# UNITED STATES PATENT AND TRADEMARK OFFICE

APPLICATION NO.	FILING DATE	FIRST NAMED INVENTOR	ATTORNEY DOCKET NO.	CONFIRMATION NO.
10/613,012	07/07/2003	Seong-Soo Kim	1572.1110	4509

# Office Action Summary

### **DETAILED ACTION**

**Fig. 3**

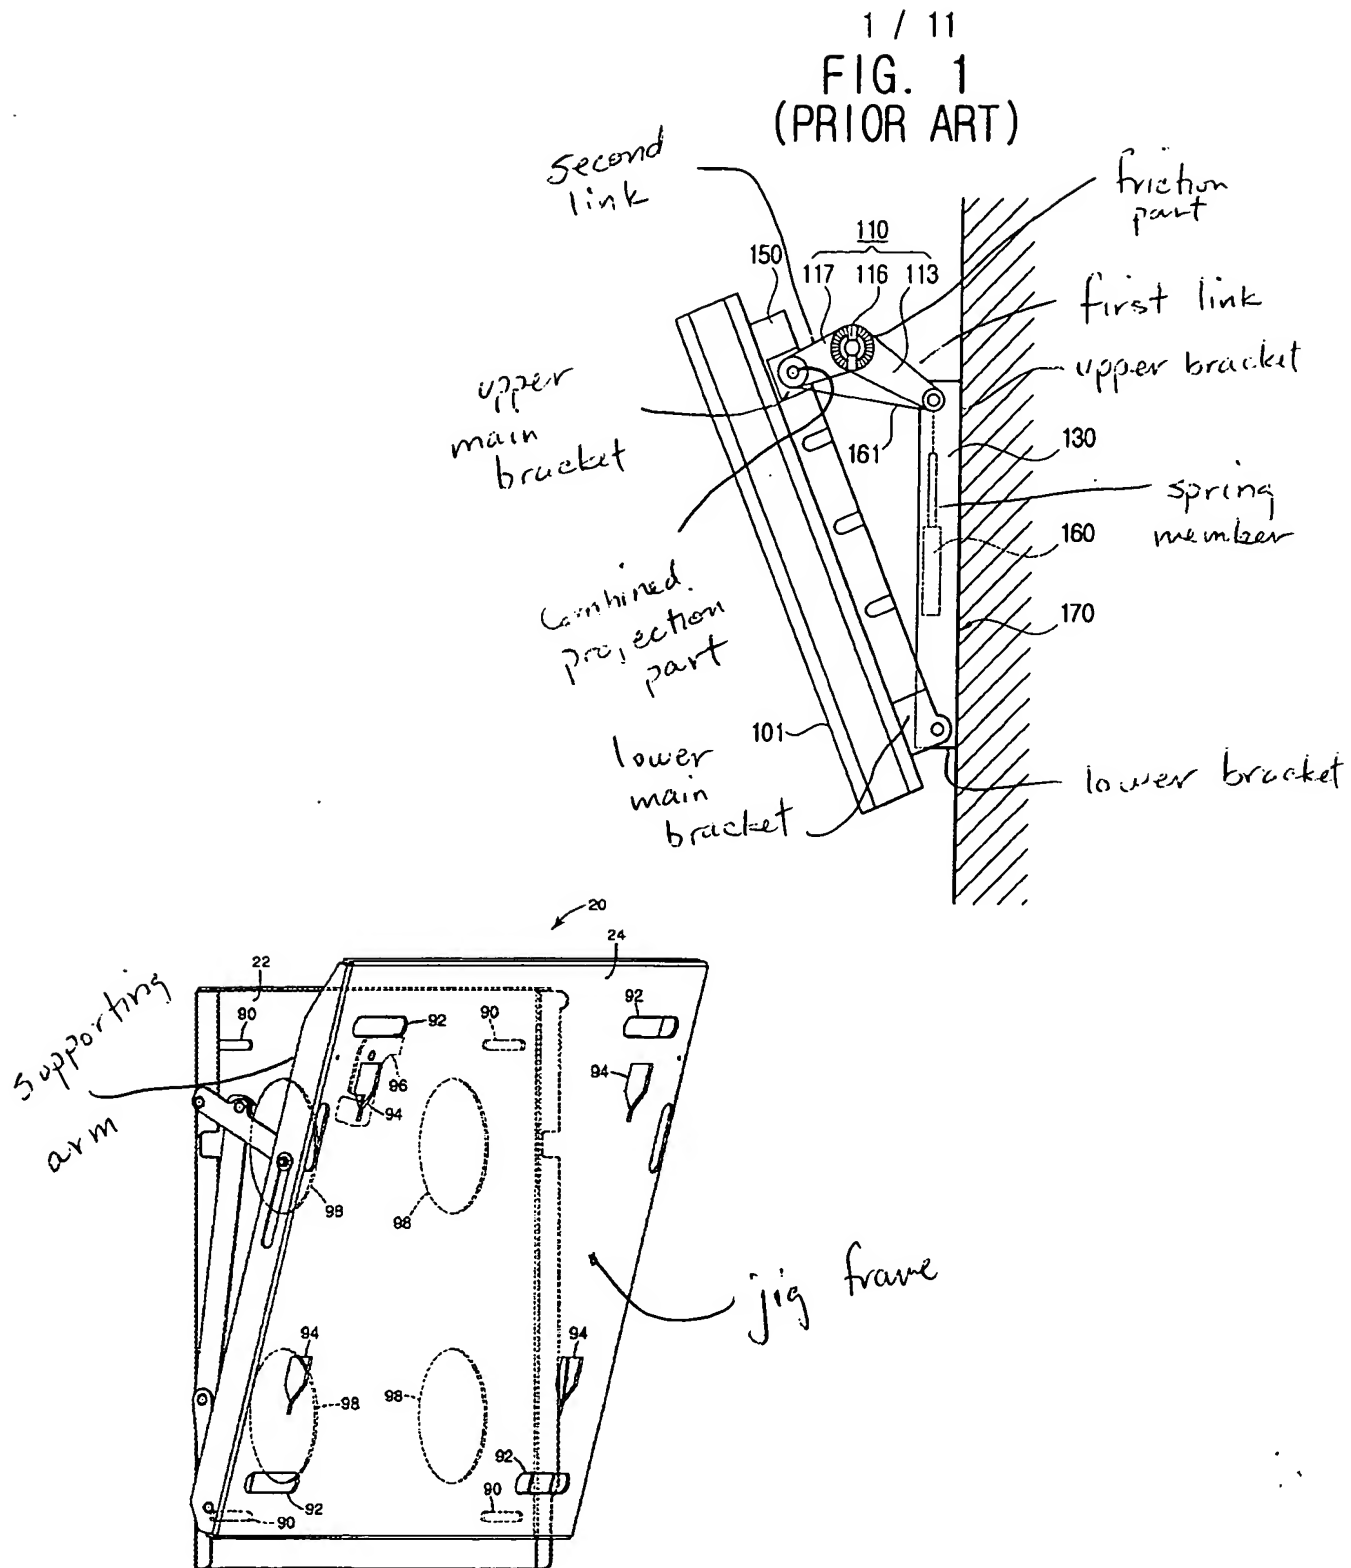
Claims 1-5 and 11 is rejected under 35 U.S.C. 102(b) as being anticipated by (JP 2000-344934, Applicant's Figure 1 Prior art), Applicant's Figure 1 prior art teaches each feature of the claimed invention as shown below.

FIG. 4

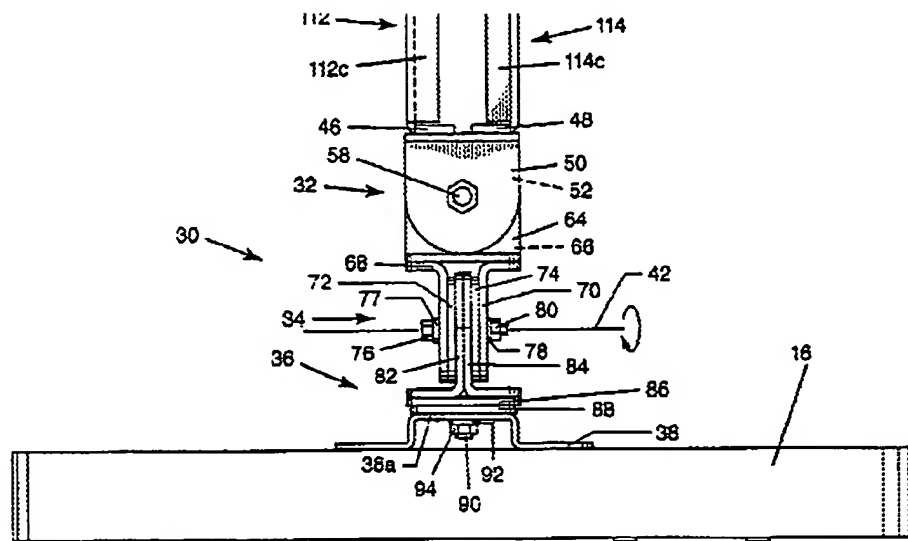
Claims 7 is rejected under 35 U.S.C. 103(a) as being unpatentable over (JP 2000-344934, Applicant's Figure 1 Prior art), in view of Uehara (6,145,797) and Sweere et al. (5,918,841). Applicant's Figure 1 and Uehara combined, teaches substantially each feature of the claimed invention as discussed above. The combination does not specifically teach a bolt passing through the torsion spring and the joint area between the first and second links and a nut matching with the bolt and at least one washer interposed between the bolt and nut. Sweere et al., however teach a display support having a two links shown held together by a nut, bolt and washers in the claimed

manner as shown below. It would have been obvious to one of ordinary skill in the art at the time of invention to have modified Applicant's Figure 1 to be connected by a nut, bolt and washer arrangement as taught by Sweere et al. in order to securely hold the joint together.

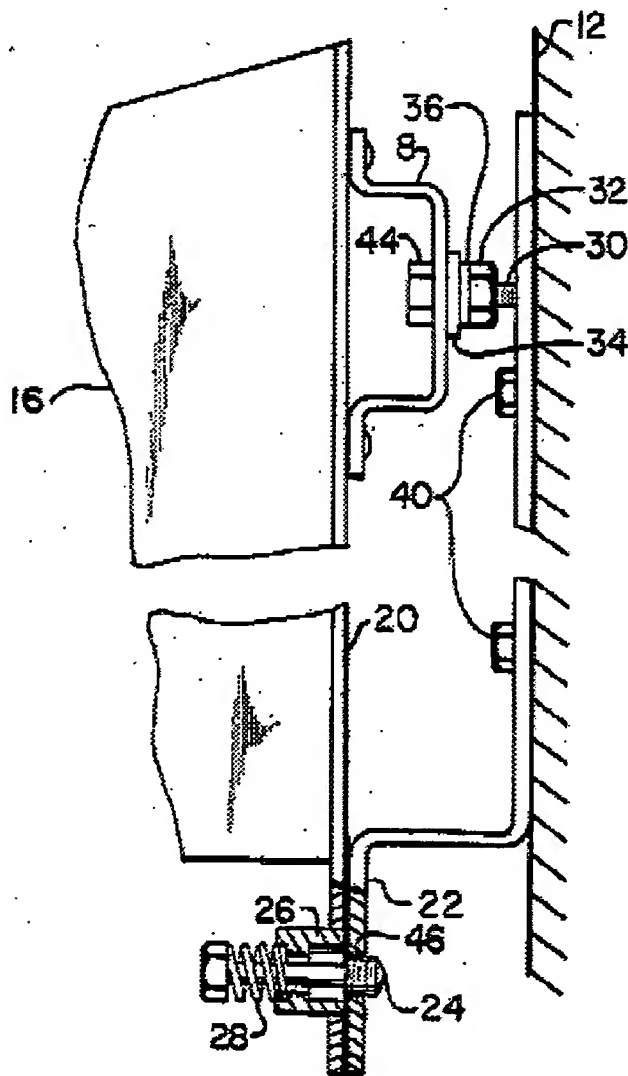
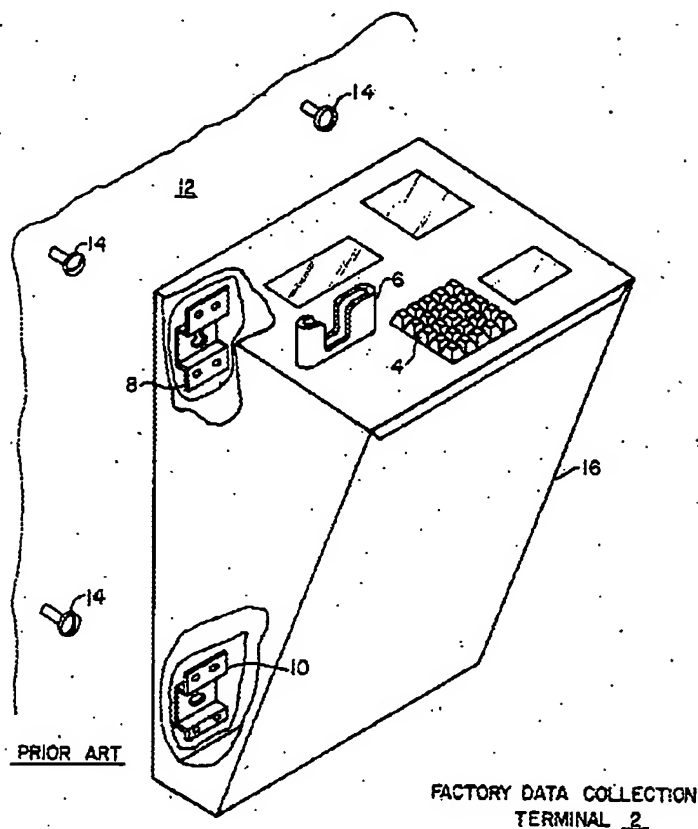
Regarding claims 8 and 9, Applicant's Figure 1 teaches brackets connected to the display main body. Applicant's Figure 1, however does not teach main brackets formed with projection holding parts in correspondence to a plurality of projections

provided in a back of the display main body. Kaplan et al., however, teach projection holding parts (8) and projections (14). It would have been obvious to one of ordinary skill in the art to have modified Applicant's Figure 1 prior art bracket (150) to be attached to his display (101) by using Kaplan et al.'s projections and projection holding parts in order to make the connection easily detachable, yet secure.
